**SITE ADDRESS: 14200 and 14420 Union Avenue**

**RE: 2<sup>nd</sup> Submittal of File No. PDC17-040:** Planned Development Pre-zoning from unincorporated to CN(PD) Planned Development Zoning District to allow for a mixed-use project with up to 238 hotel rooms, up to 150,000 square feet of office, up to 115,000 square feet of commercial, up to 280 multifamily residential units, up to 84 townhouse residential units and/or cluster housing, up to 130,000 square feet of convalescent hospital, and 1.6 acres of public open space on a 18.13-gross acre site at the southeast corner of Union and Camden Avenues, commonly known as Cambrian Park Plaza Shopping Center.

### Sheet 2.1: Development Standards

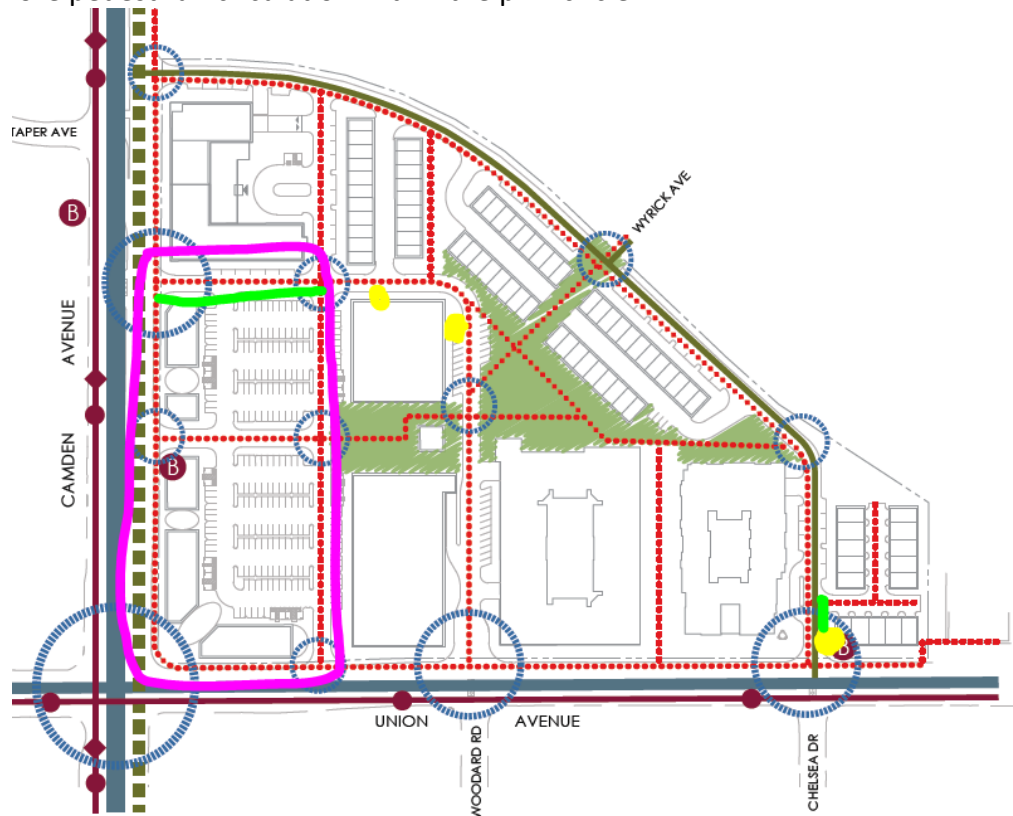
- See the 2<sup>nd</sup> draft of the development standards at the end of this document. I've made my changes in red and I've also included a clean copy at the end for easy reading.
